## addendum

**project:** 2006/07 CDBG Public Facilities – Washtenaw County  
**rfp number:** 6343  
**project number:** 06712.1

**addendum number:** One (1)  
**date issued:** October 10, 2007

**DETECTABLE WARNING DETAILS**

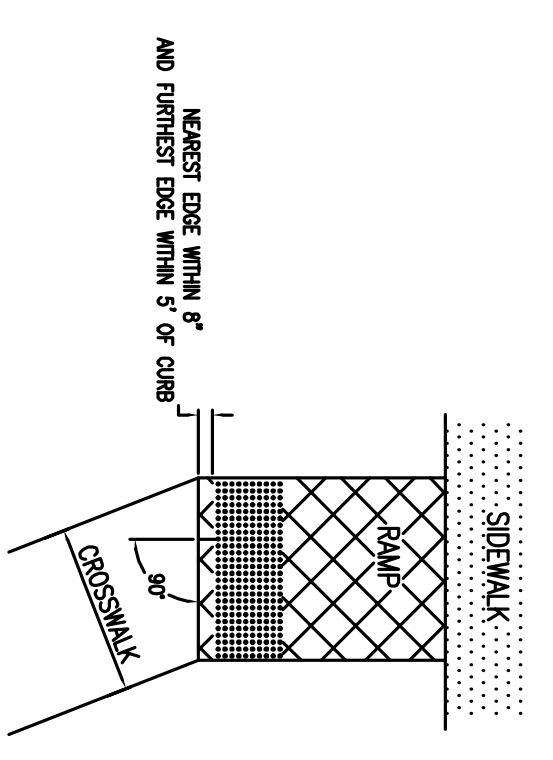
- 9: Changed all sod notes on drawings to hydroseeding
- 10: Added detectable warning to Coachville Blvd. driveway crossings
- 11: Added note to C-1 to indicate M-DOT traffic maintenance requirements

BASE FLANGE MANHOLE AND CATCH BASIN COVERS

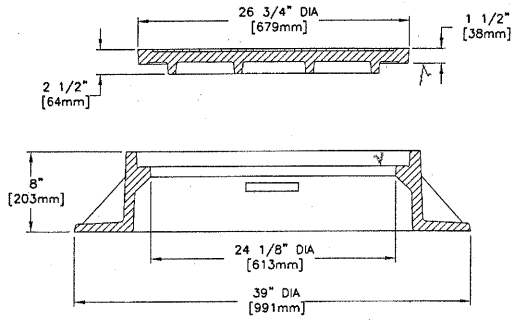
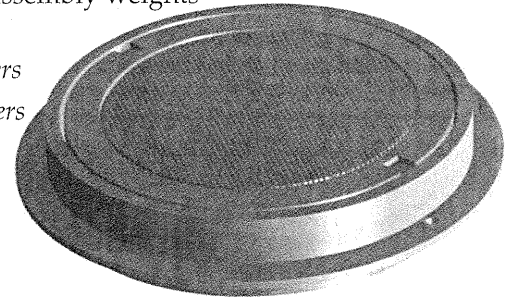
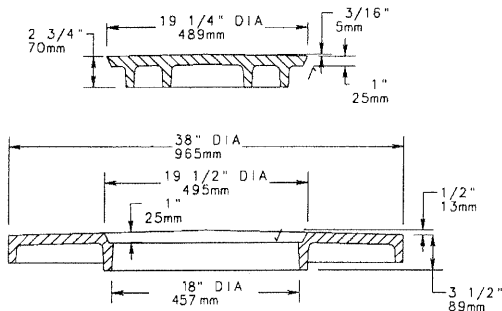
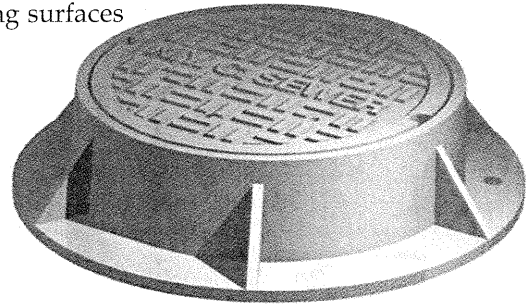
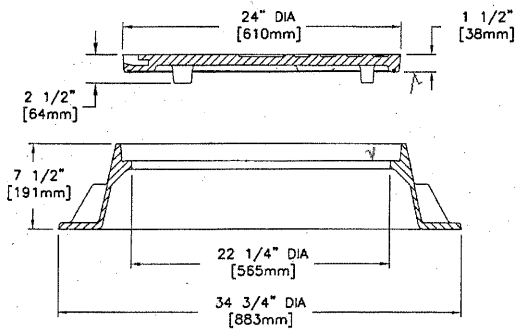
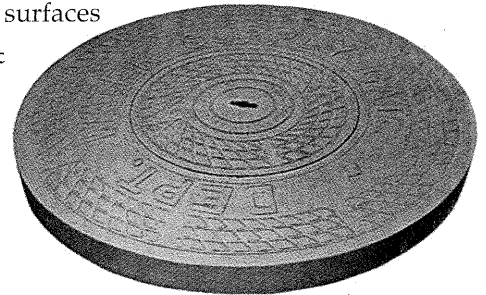
- 12: Included Pittsfield Standard Detail for gate and watch valve revisions (See attached Drawing Detail).
